SOUTH ELEVATION APPROVED DESIGN

SOUTH ELEVATION PROPOSED REVISION

BANK OF BEAVERTON BUILDING
 ALTERATION OF HISTORIC LANDMARK
 4500 SW WATSON AVE
 BEAVERTON, OR 97005
 09/28/2020

2 SOUTH ELEVATION PROPOSED REVISION
 1/8" = 1'-0"

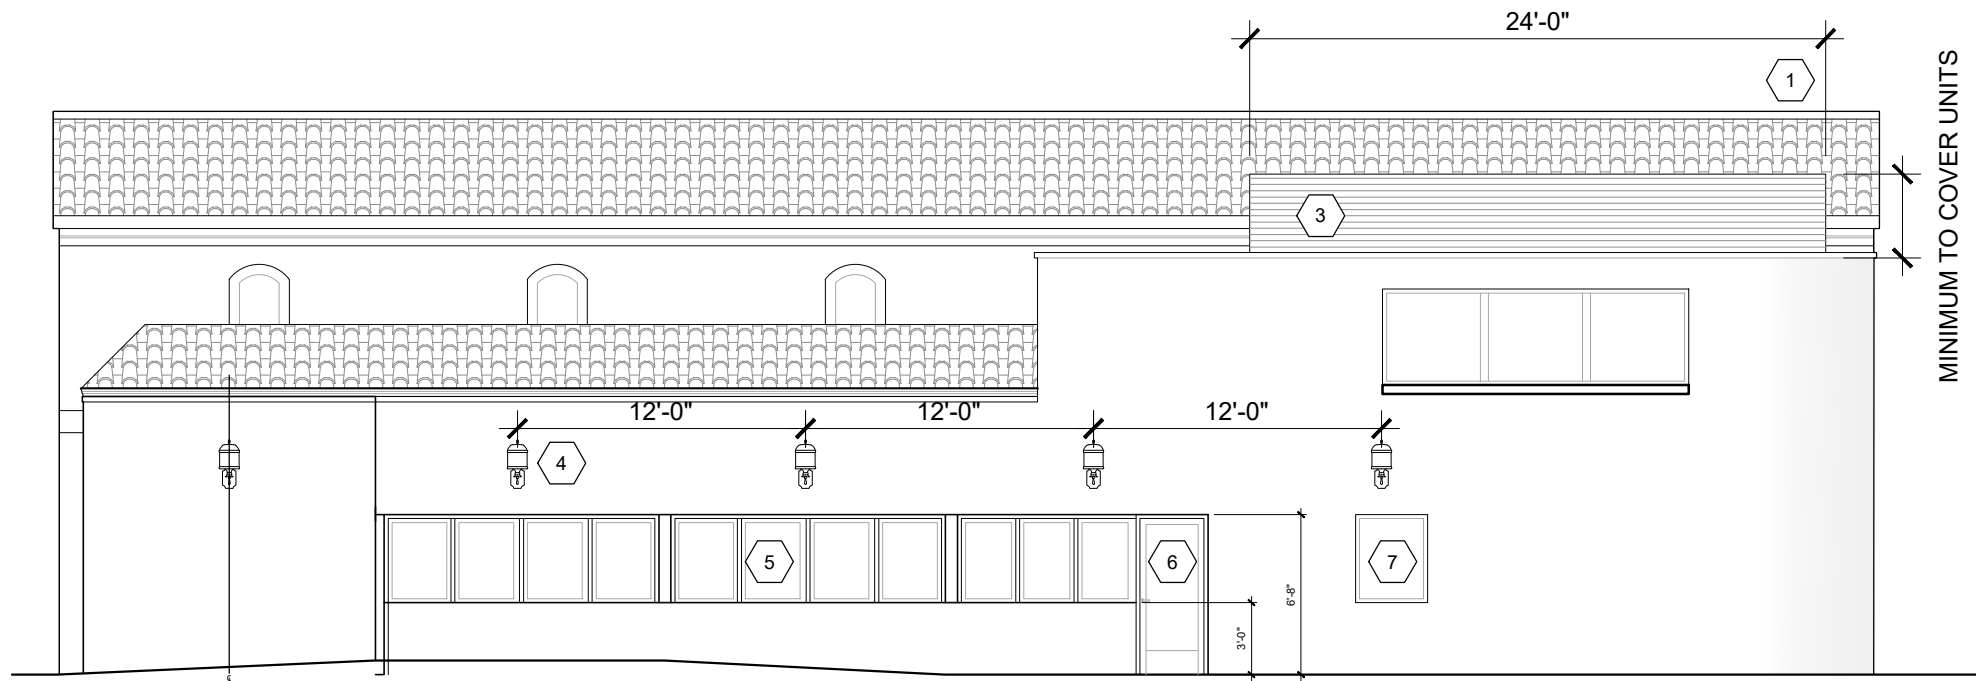
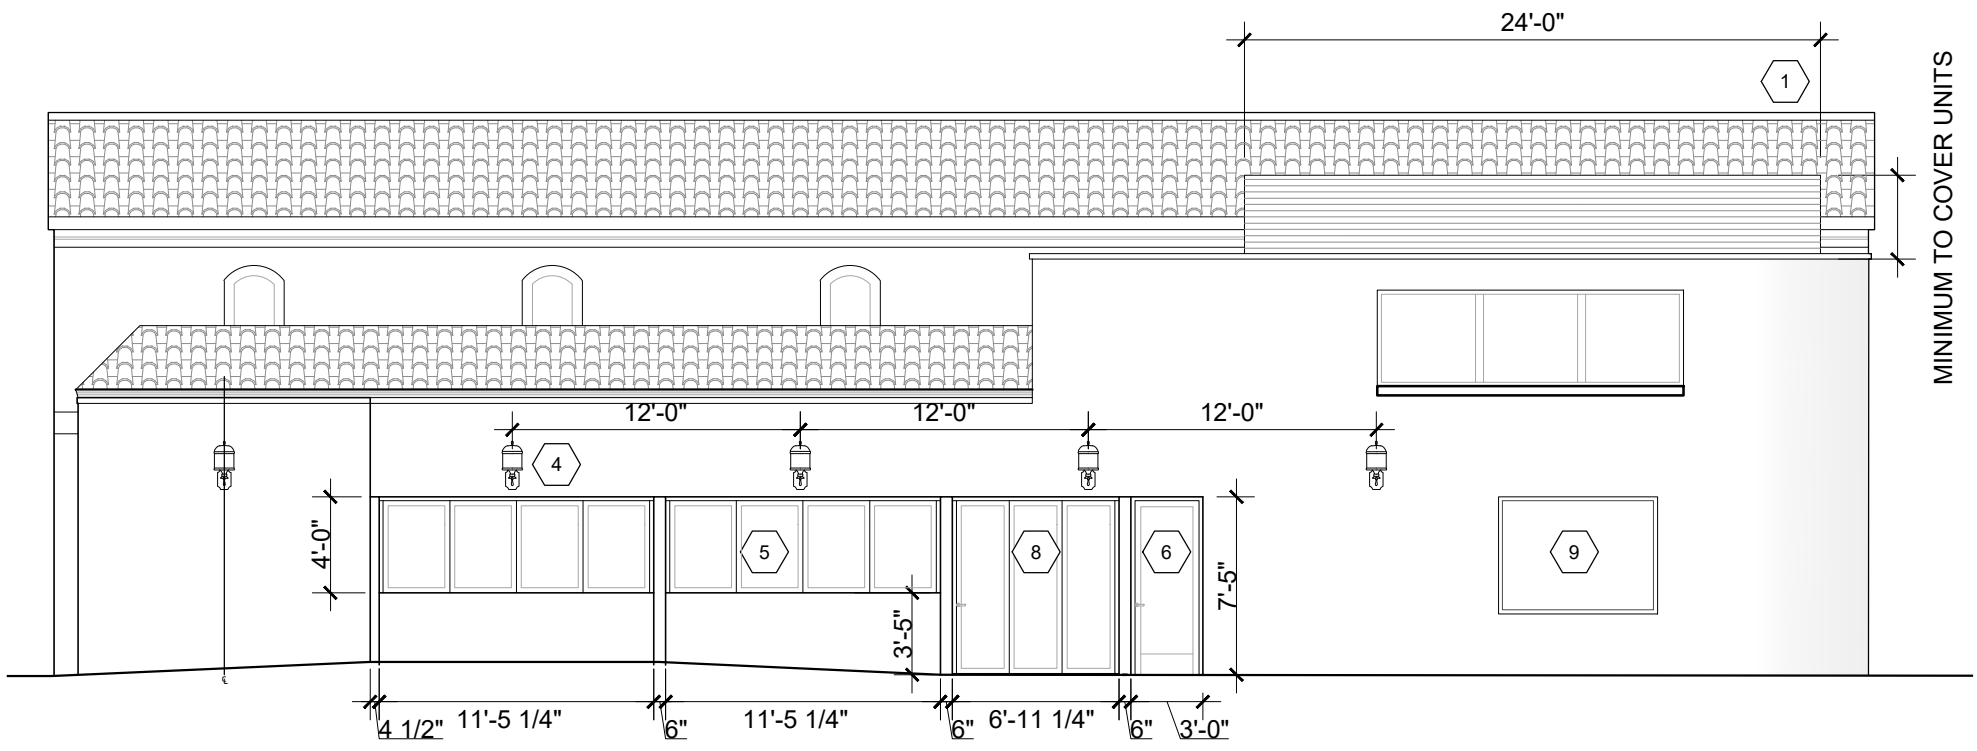
- 1 CHIMNEY VENT REMOVED (SEISMIC HAZARD) AND PORTION OF REROOFED
- 2 (N) PERIOD-CORRECT ARCHED LOUVERED WINDOW TO REPLACE DOOR
- 3 (N) ROOF MECHANICAL EQUIPMENT SCREENING METAL PANEL
- 4 (N) EXTERIOR SCONCES
- 5 (N) SLIDING STOREFRONT WINDOW
- 6 (N) EXIT DOOR - TEMPERED U:0.32
- 7 (N) WINDOW
- 8 (N) EXTEND PROPOSED WINDOWS TO FLOOR
- 9 (N) WINDOW IN EXISTING OPENING
